Final Value Engineering Study Report

Monterey Peninsula Water Supply Project Desalination Plant

August 2014

Subject: Final Value Engineering Study Report
Monterey Peninsula Water Supply Project – Desalination Plant

VE ALTERNATIVE TP-13

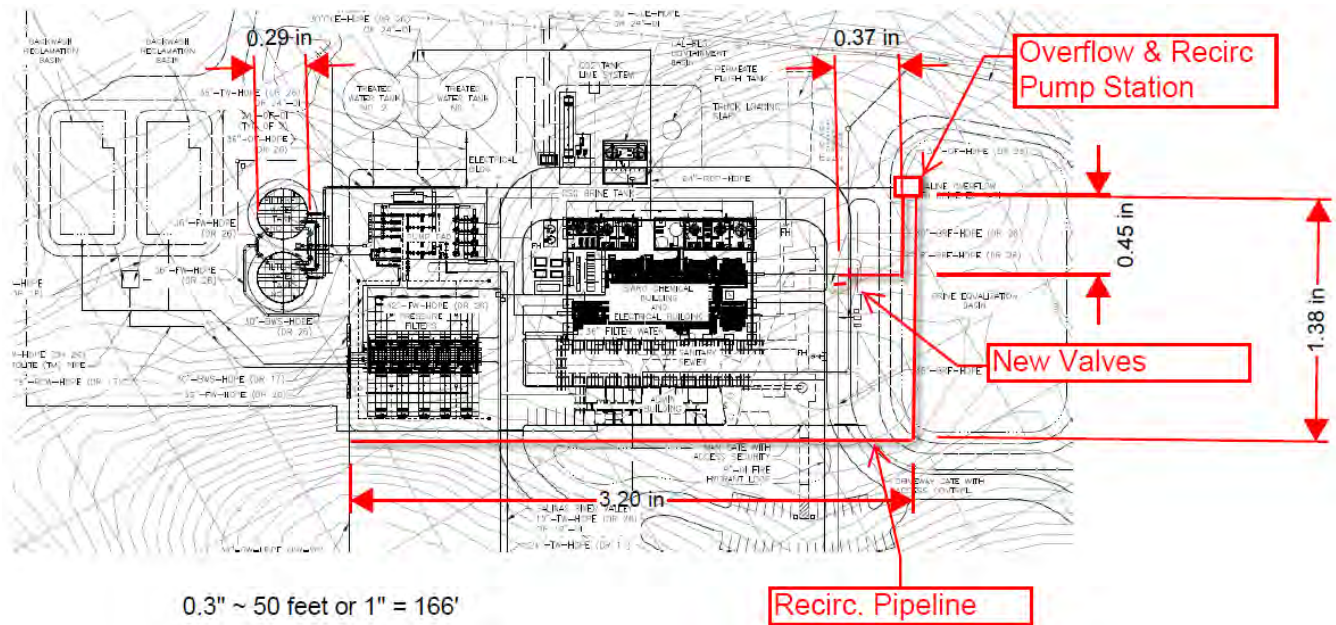
For 6.4 MGD plant option, eliminate brine pit and circulate the permeate and brine until discharge is allowed
